Versatile Textiles Limited (New Buildings)

4th June 2018

Observations

High stress column

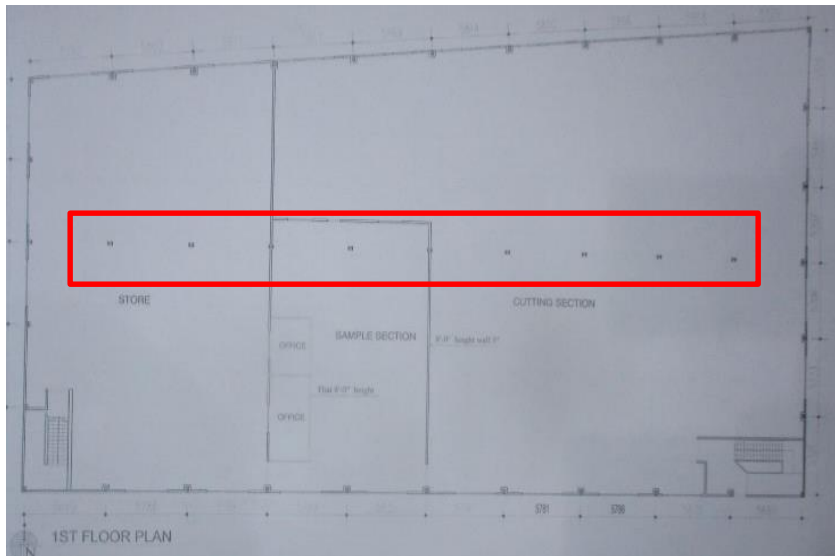
Cursory calculation shows that the stresses of central columns exceed the normal design limit at ground level. Detail Engineering Assessment (DEA) to be commenced immediately based on in-situ steel strength.

Typical frame section

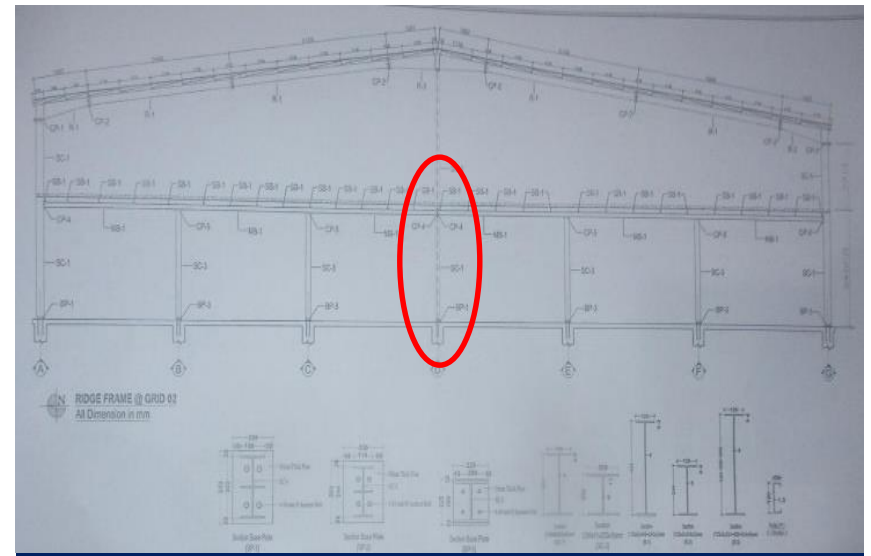
Floor loading observed around 3KPa on 1st floor. No load plan found on site. Building engineer is required to produce a safe floor load plan and maintain accordingly.

Portal frame at 1st floor

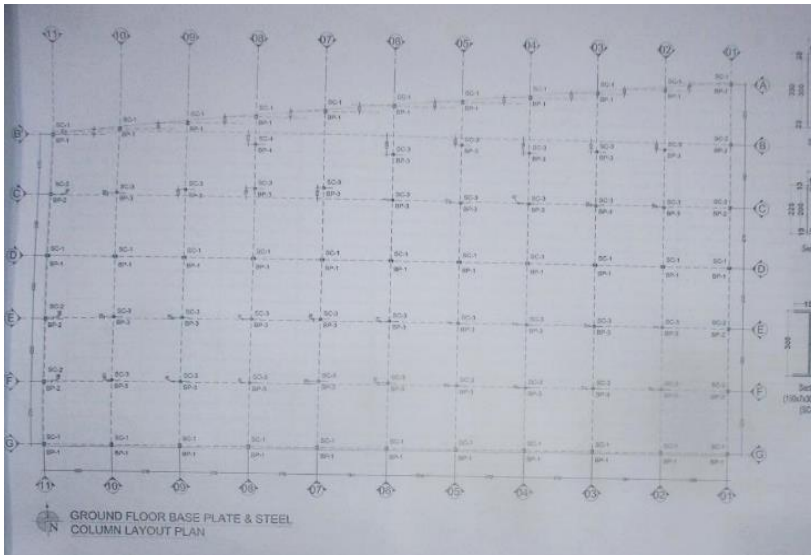
The ground floor beam-column connections were flexible and lateral load resisting system was absent. Compression strut and vertical bracing was not observed for the steel portal frame structure on roof. Also, the horizontal cable bracings were loose and there was no alternative lateral load resisting system. Factory engineer to check the stability of the structure against code defined lateral and gravity forces as part of Detail Engineering Assessment (DEA).

Steel column layout

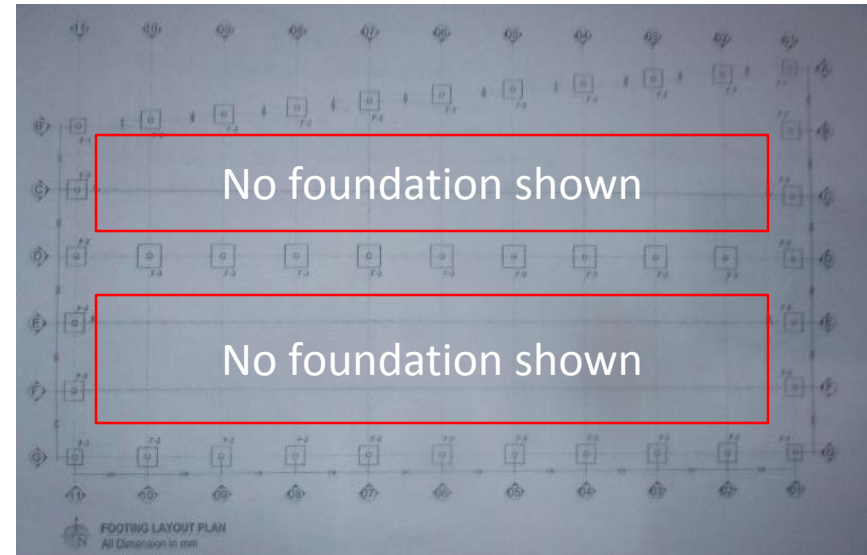
As per drawings, the steel columns are shown in every grid location. But the foundation layout shown only for the periphery and central columns. Also, there is no detail for RC floor slab and stairs.

Frame section in approved drawing

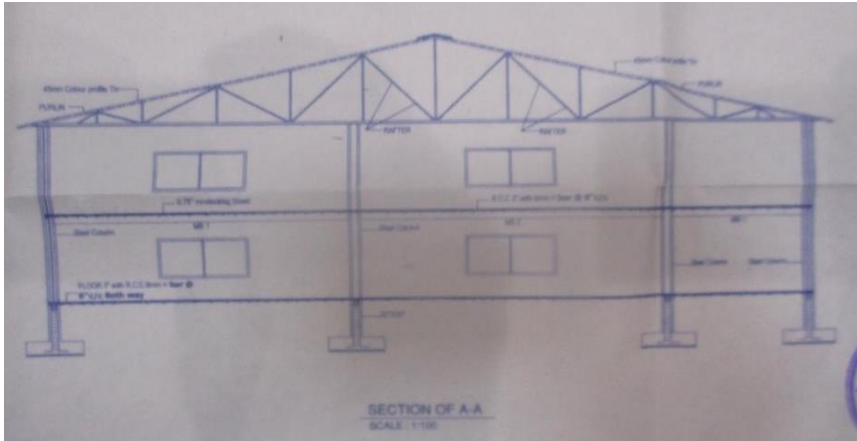
Truss roof system was approved but portal frame system was constructed without any design consideration.

Frame section in grid-10

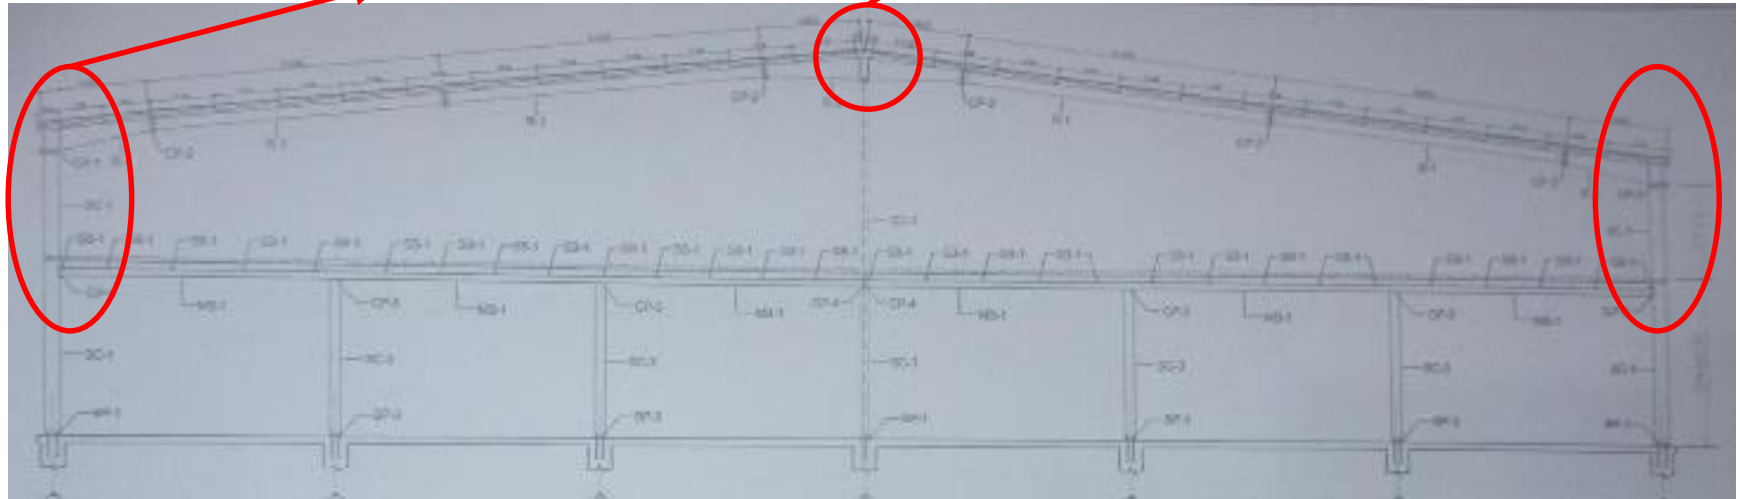
Steel column flange thickness observed 6mm instead of 7mm.

Depth 450mm instead of 500mm

Discrepancies observed in the sectional dimension of SC-2 columns and rafter at ridge. Building engineer is required to update the as-built drawing and design documents.

Crack on brick walls

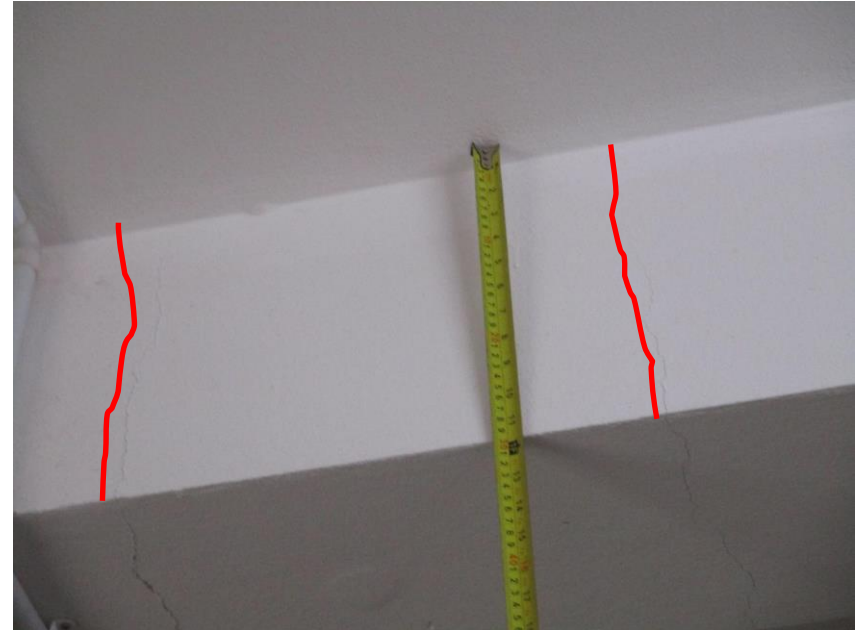
Vertical cracks were observed on joints of the brick walls. Building engineer to investigate the cracks and prepare an investigation report with proper remedial measures.

Mismatch in as-built drawings

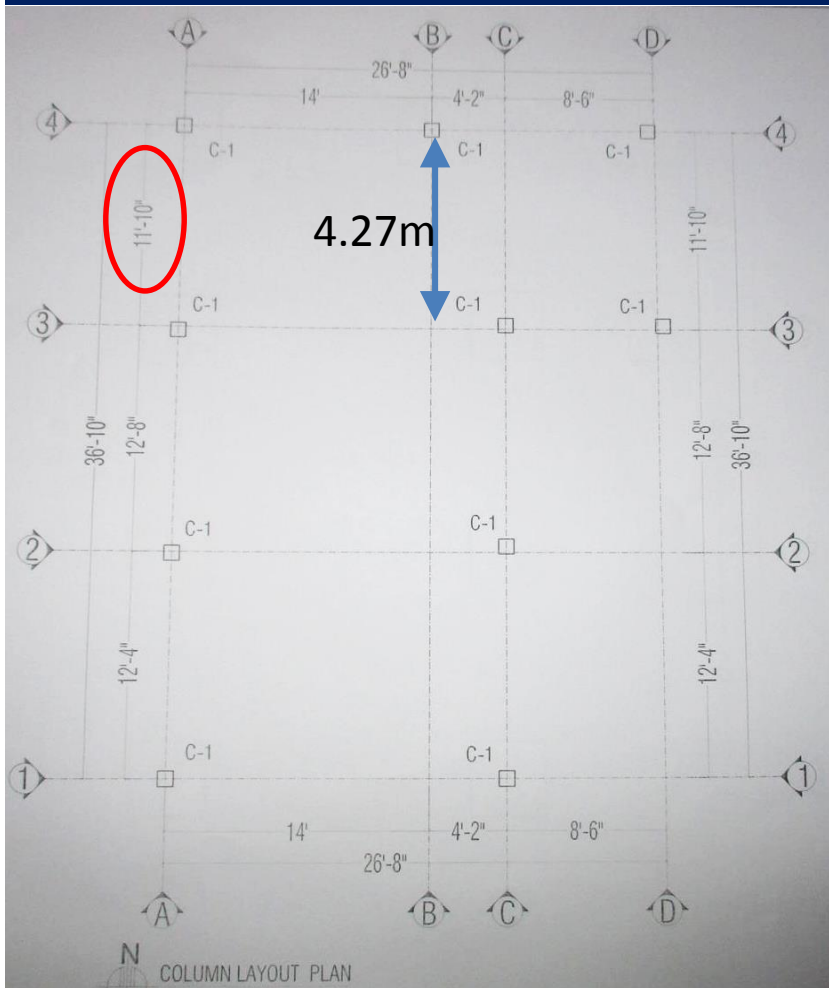
The distance between grid 3&4 was measured 4.27m where drawing shows 3.36m. The drawings to be updated.
